Newport Harbor High School Narrative Changes – Mechanical Addendum 1

January 26th, 2021

Attention: Mr. Lance Bidnick
Project: Newport Harbor High School
Newport Beach, California 92663
Subject: Narrative Changes – Mechanical Addendum 1

SCALE:	B
NONE

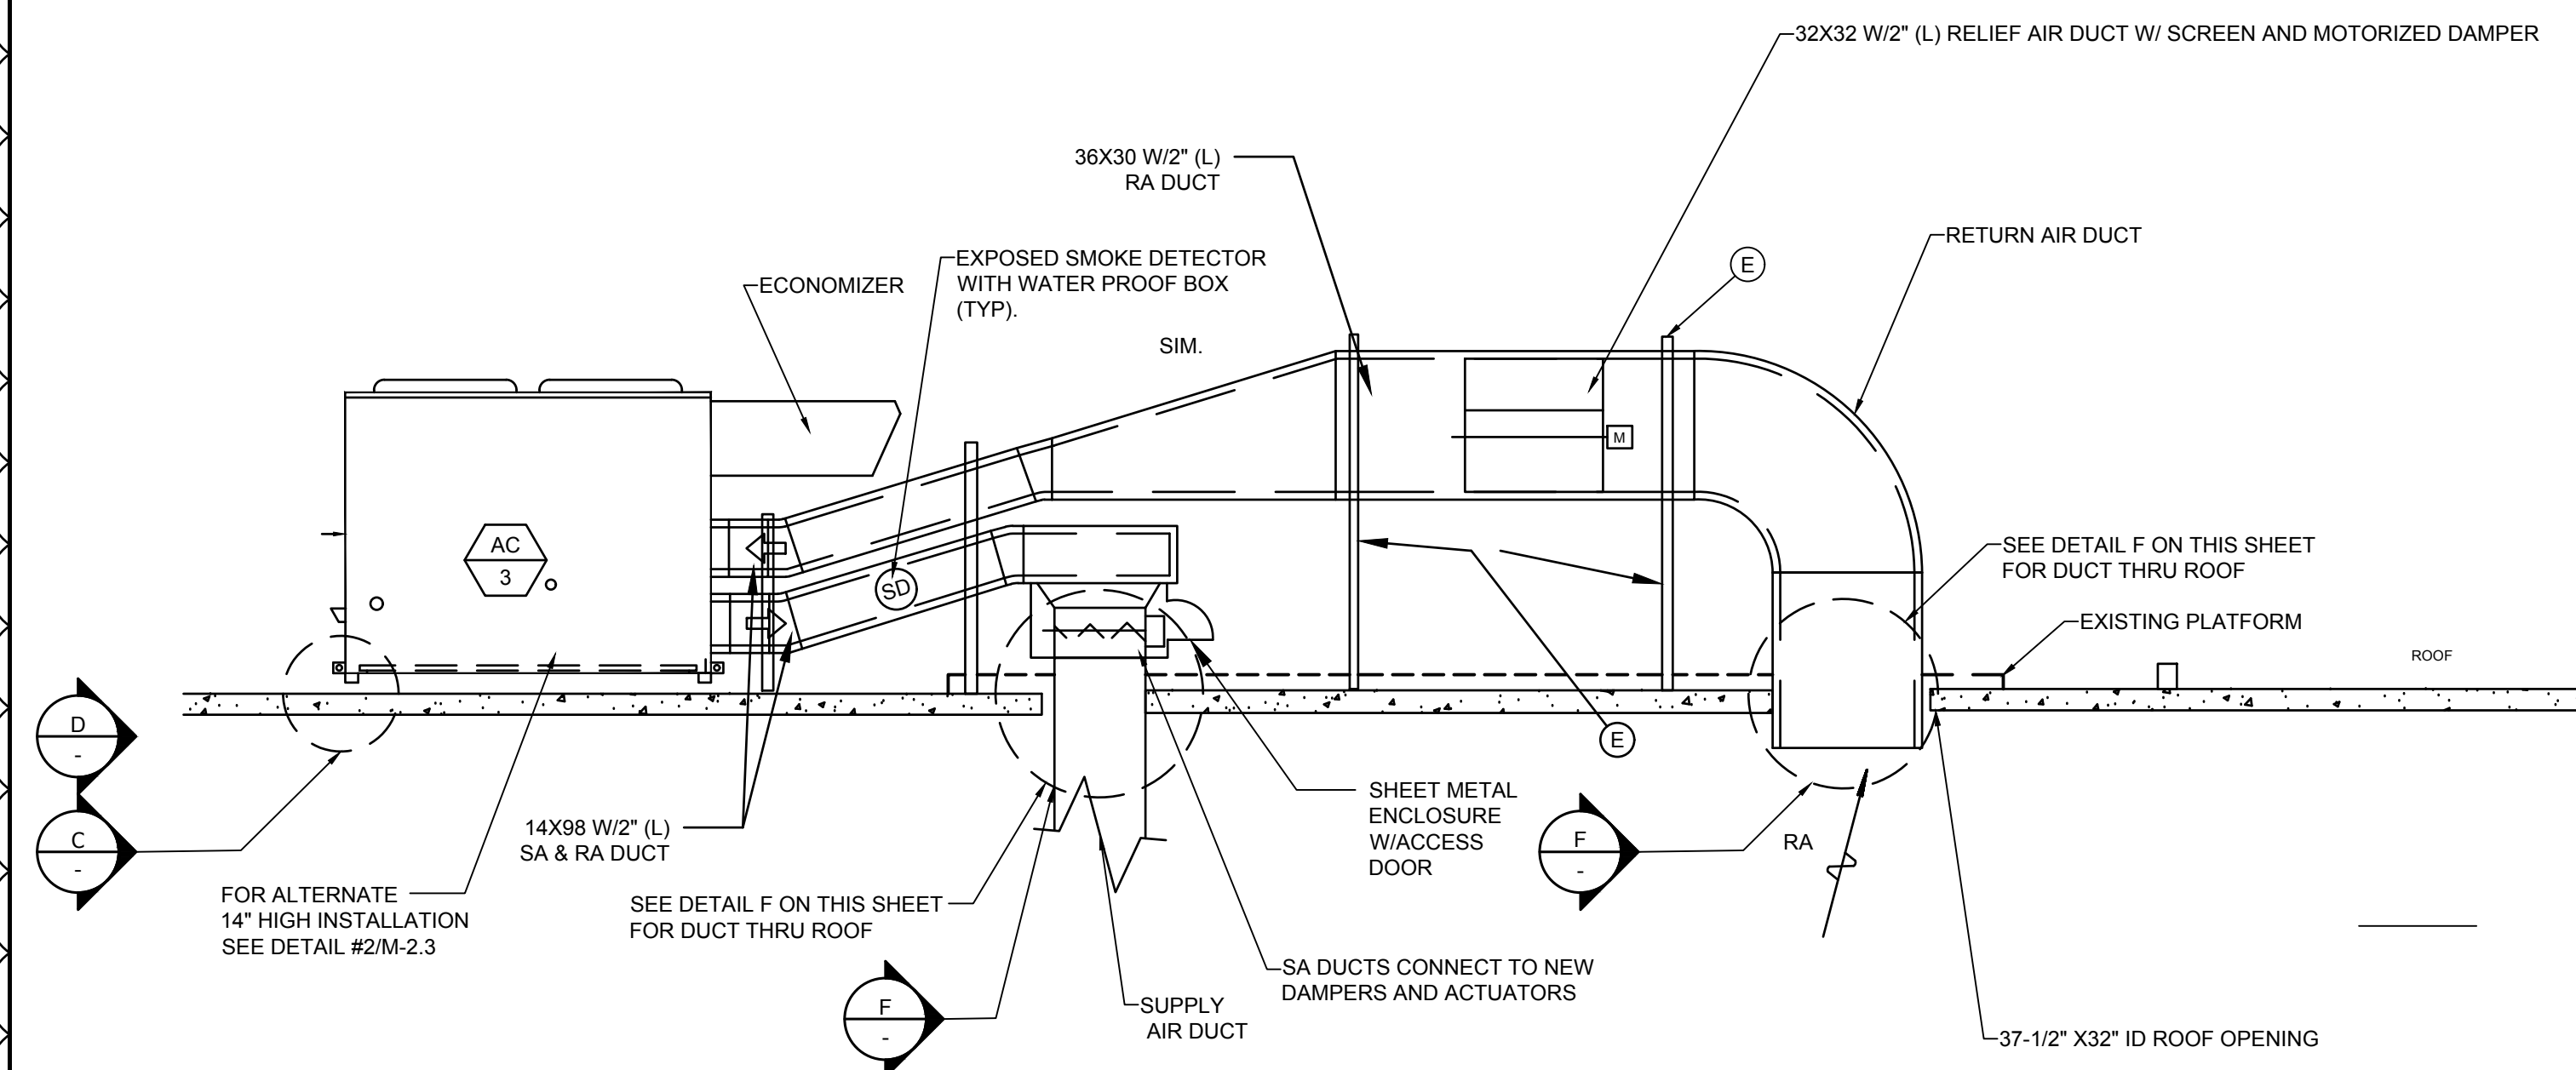
Detail B

1. Revised detail to display existing platform for duct drops and supports. Revised label to indicate curb is existing and not new as it was shown previously. See delta 1 cloud.
2. Revised detail to include reference to detail F duct thru roof.

SCALE	E
NONE

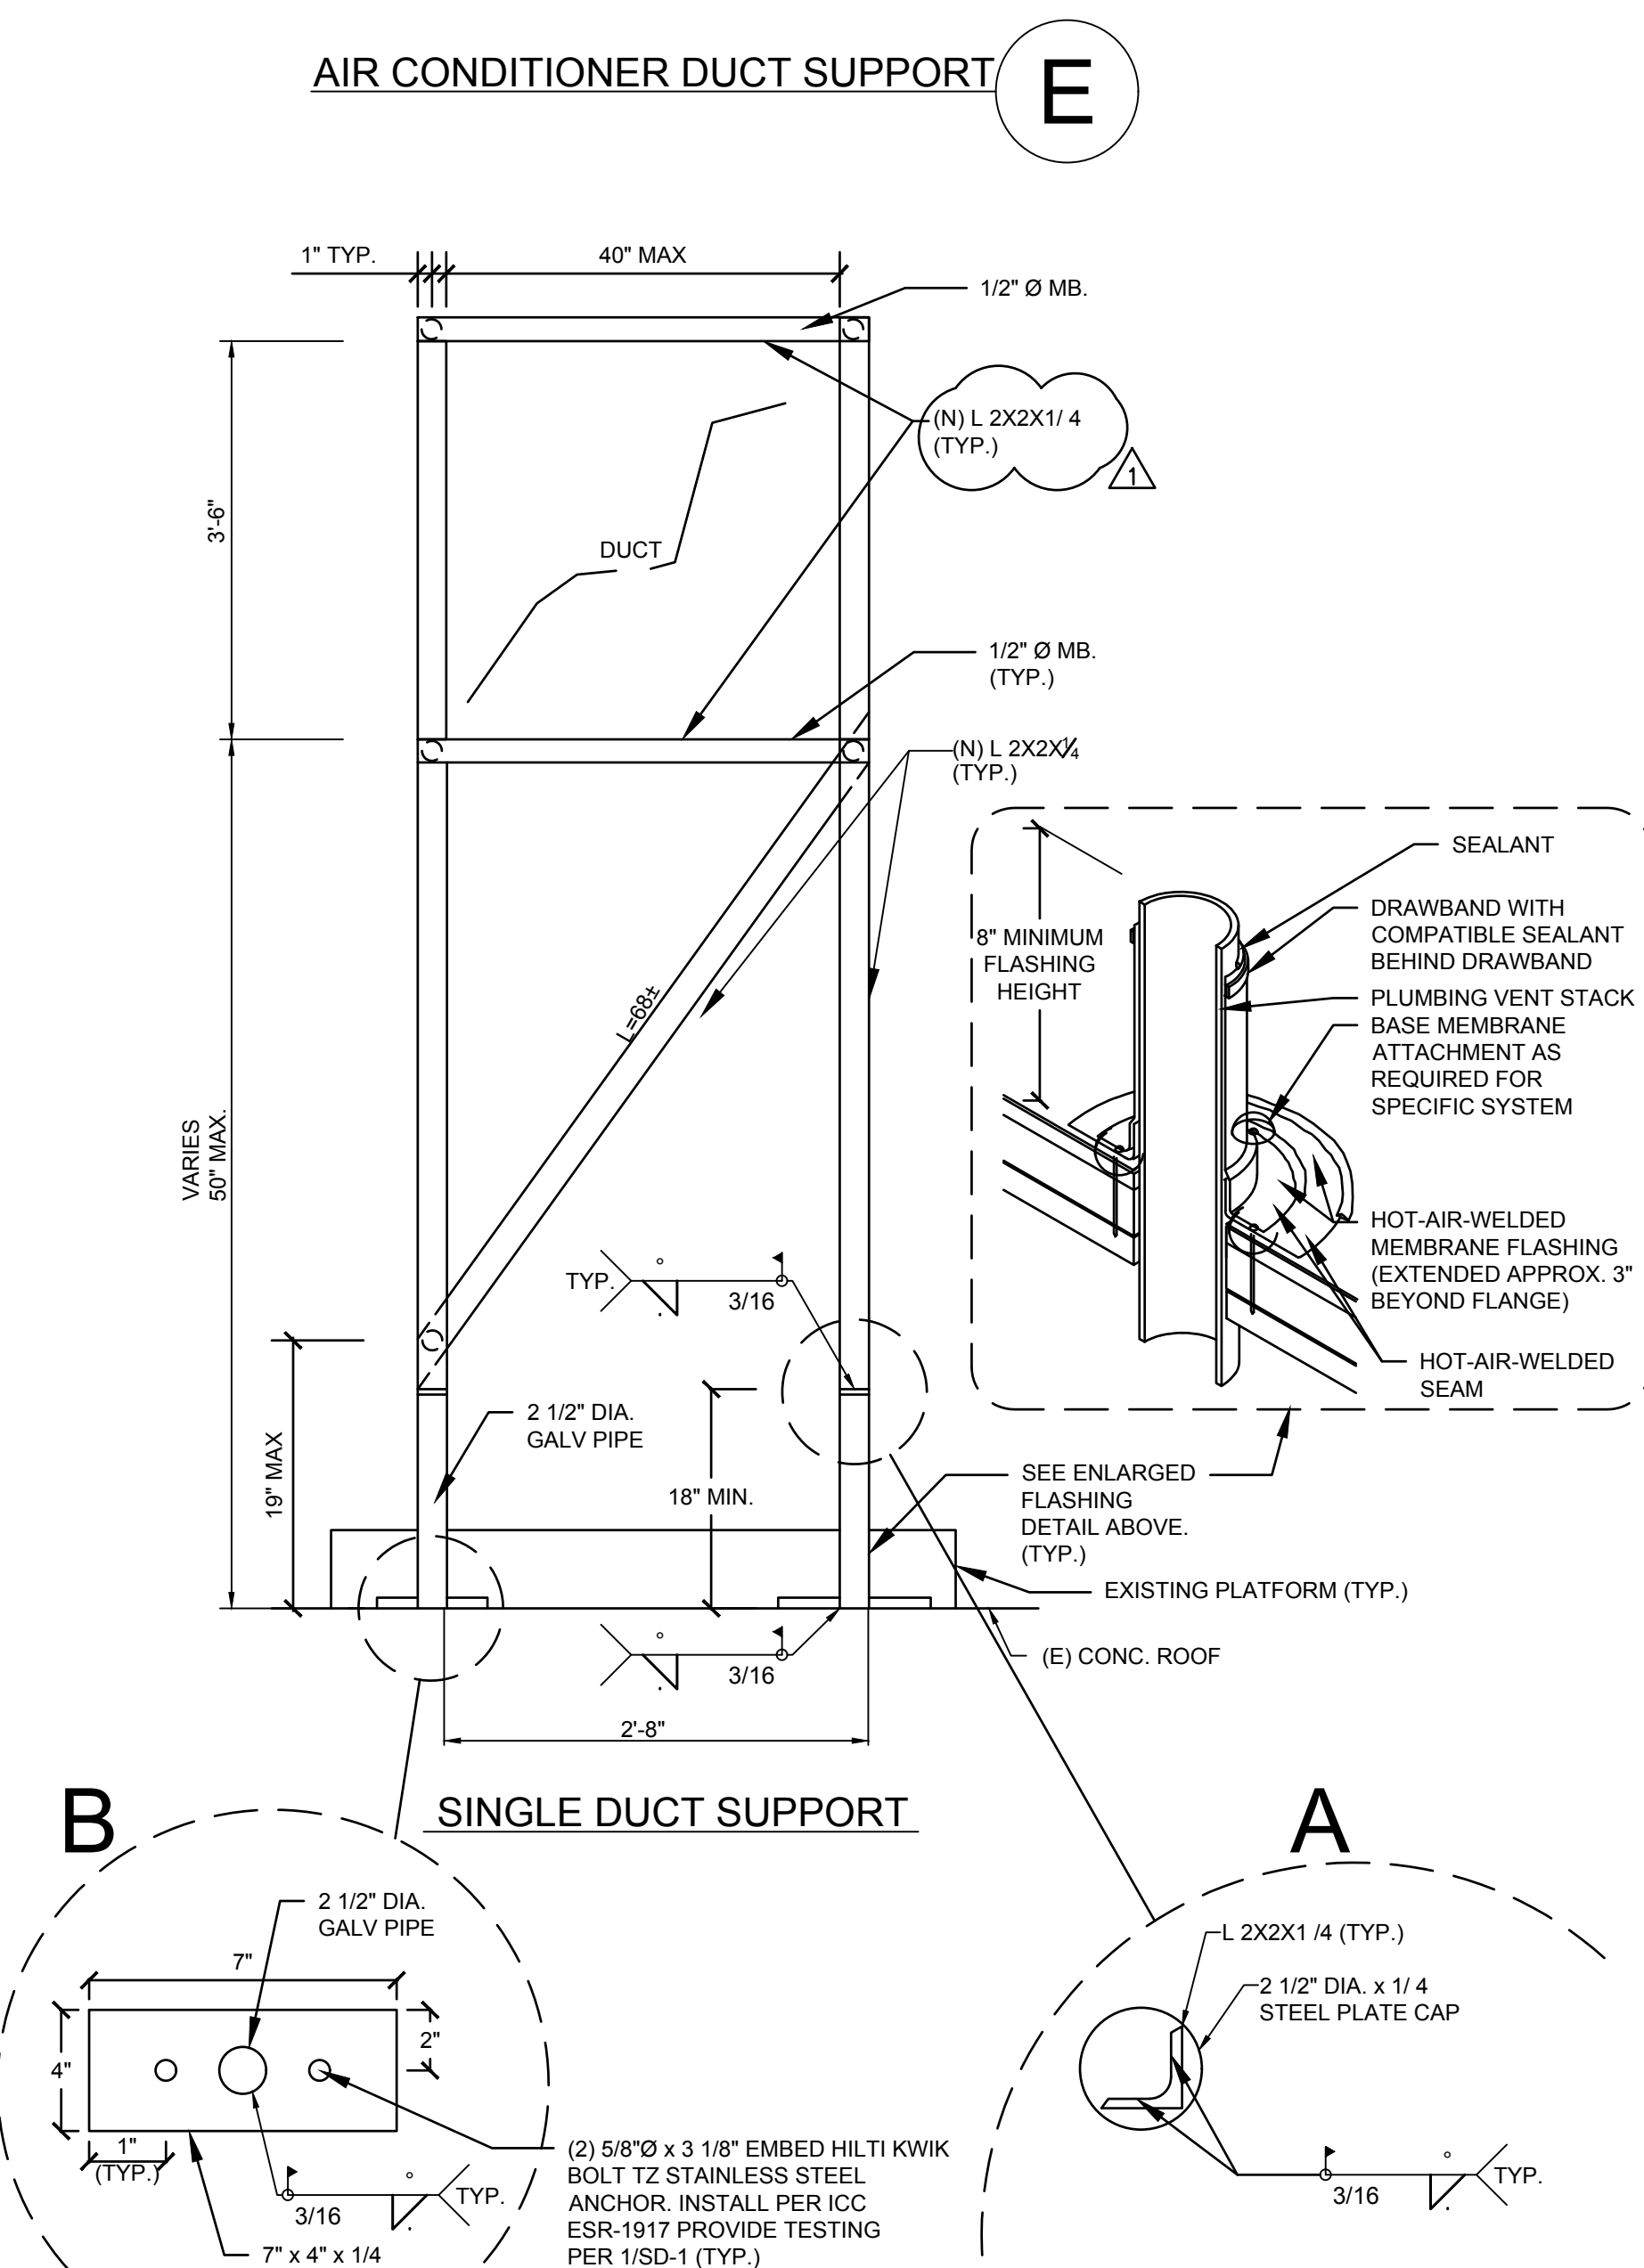
Detail E

5. Revised detail to identify duct supports as new (previously shown as existing). See delta 1 cloud
6. Revised duct supports to round base and flashing. See delta 1 cloud.
7. Revised detail including enlarged views to reflect new assembly with round base.
8. Added enlarged isometric view for flashing pipe/boot in detail E.

PERSONAL FALL ARREST PROTECTION ANCHORAGE

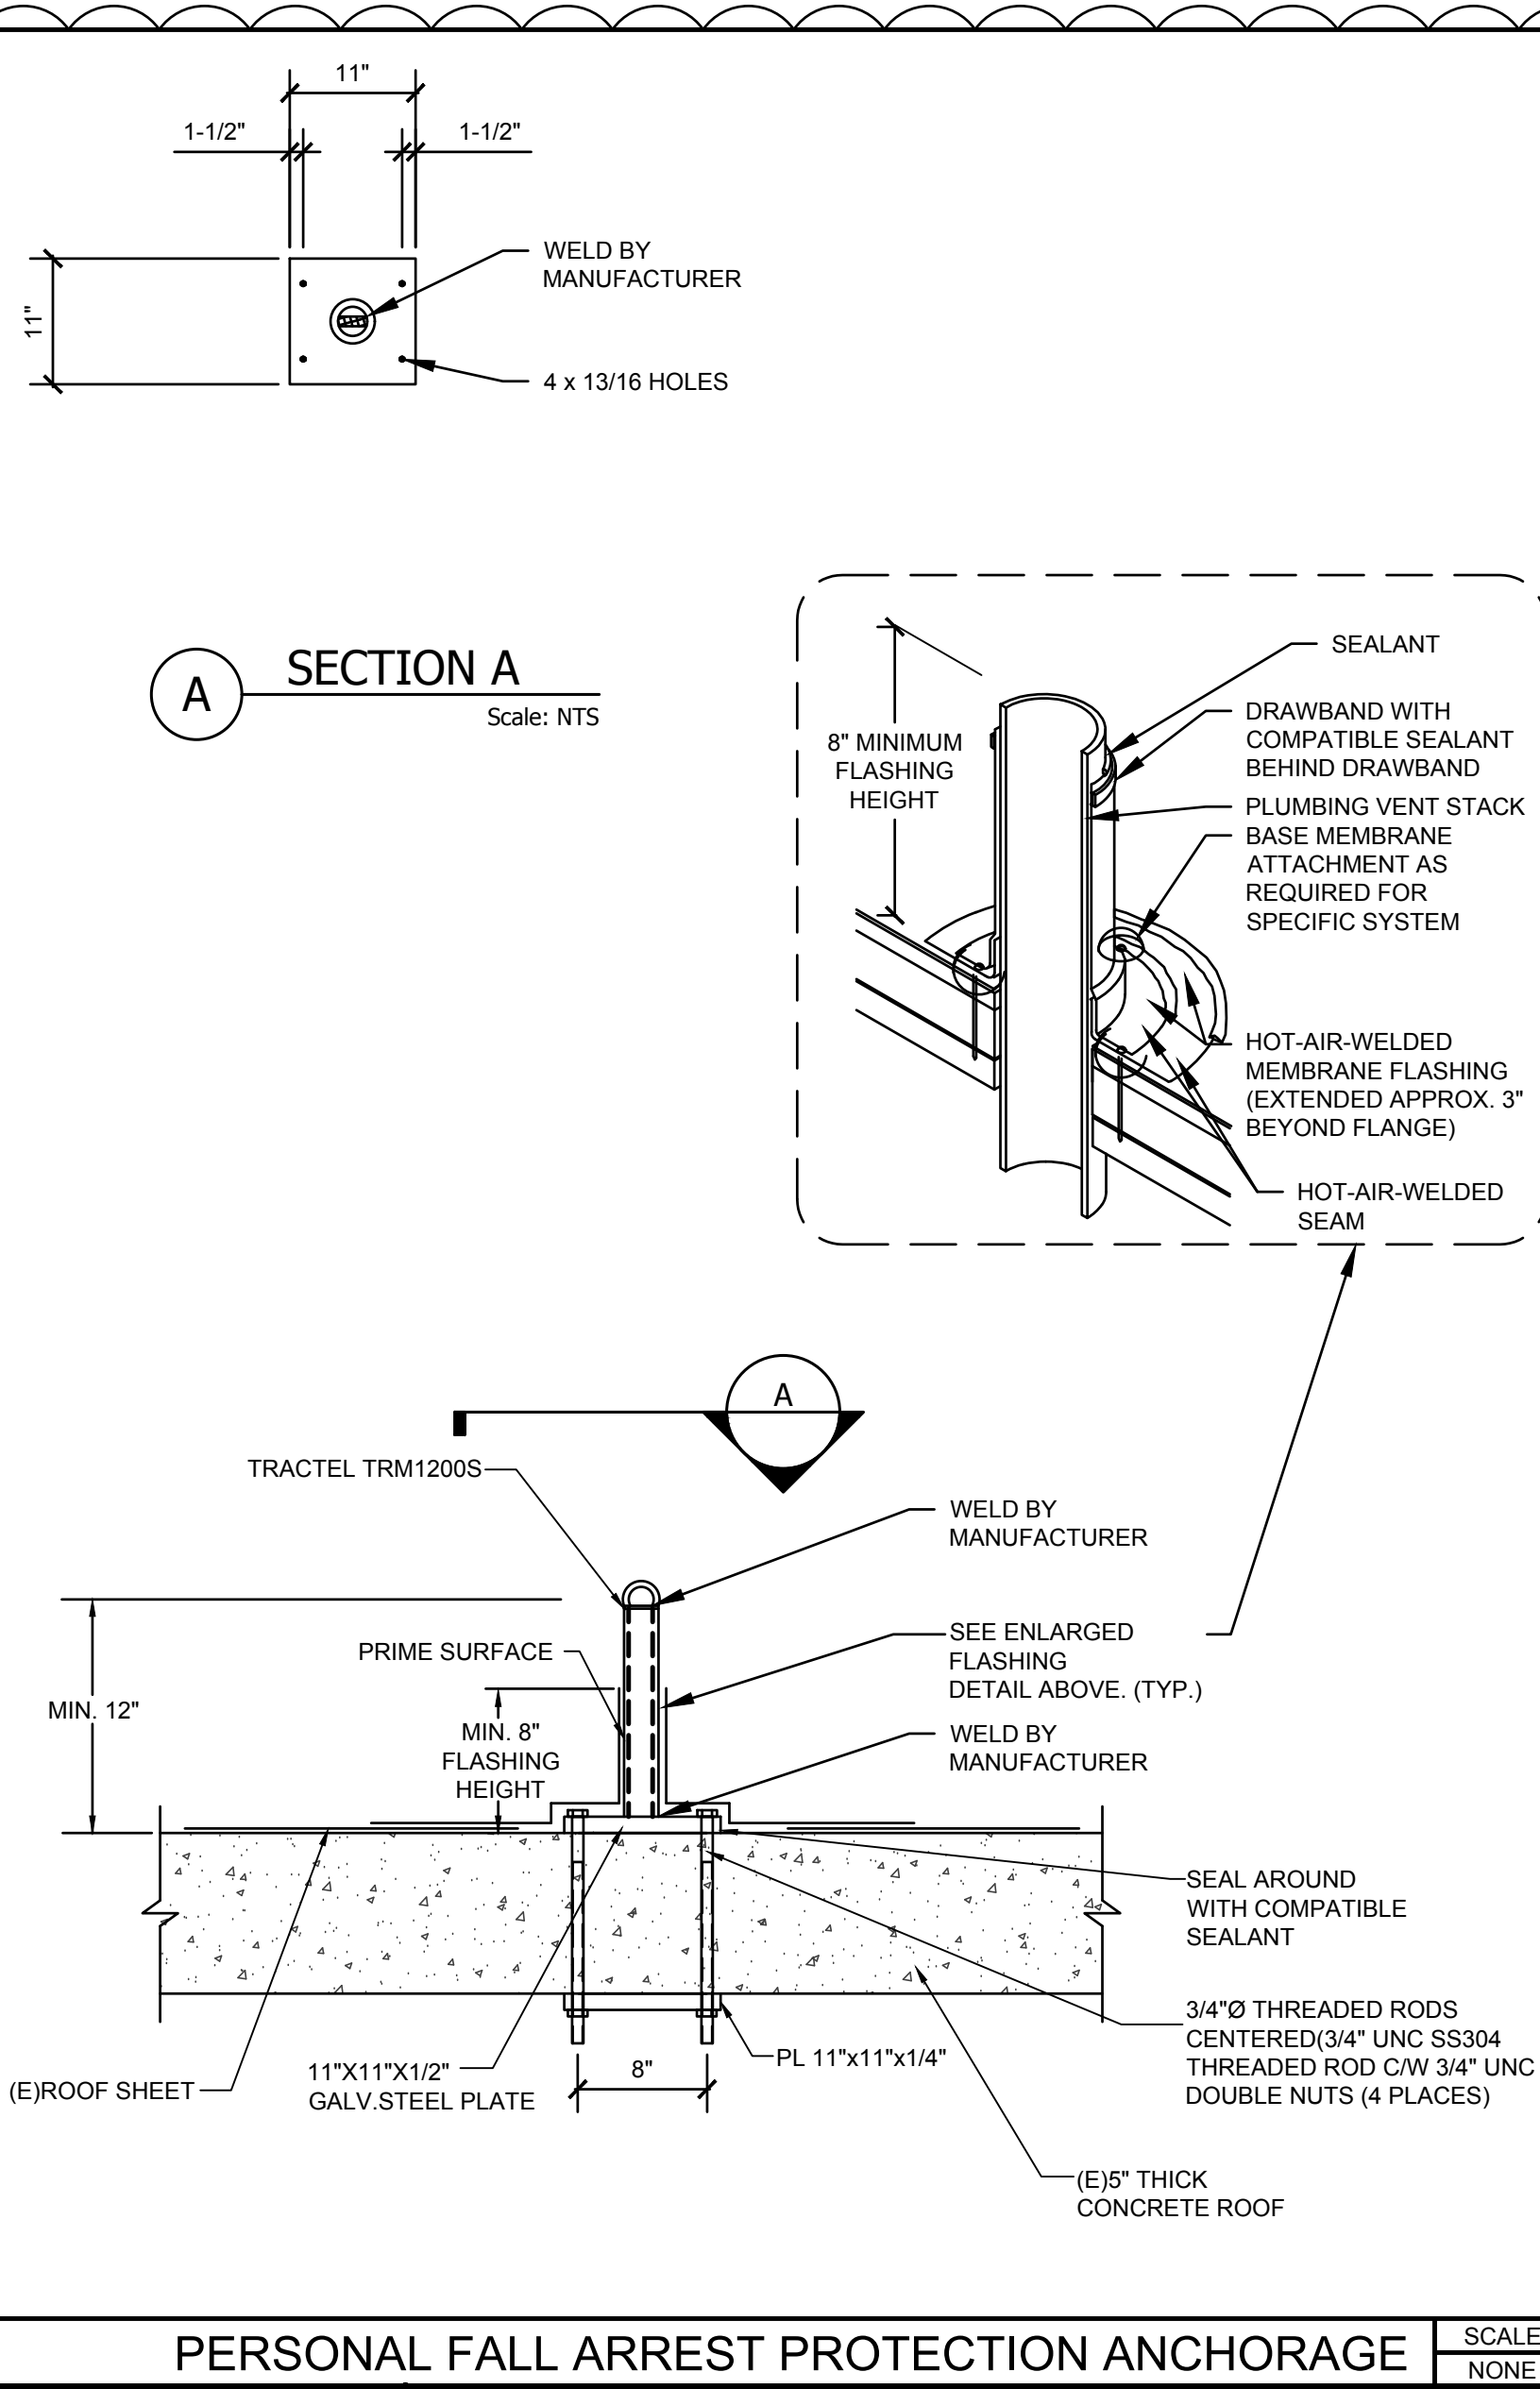
1. Revised detail 2 to identify duct supports as new (previously shown as existing). See delta 1 cloud
2. Revised detail 2 duct supports to round base and flashing. See delta 1 cloud.
3. Revised detail 2's enlarged views to reflect new assembly with round base.
4. Added enlarged isometric view for flashing pipe/boot in detail 2.
5. Revised detail 3 specifying Tractel TRM1200S for fall protection in place of Guardian CB-1. See revised sheet for changes.
6. Revised top view of fall protection detail #3. Size of base plate, and minimum edge distances to fit TRM1200S.
7. Added enlarged flashing detail for fall protection detail #3.
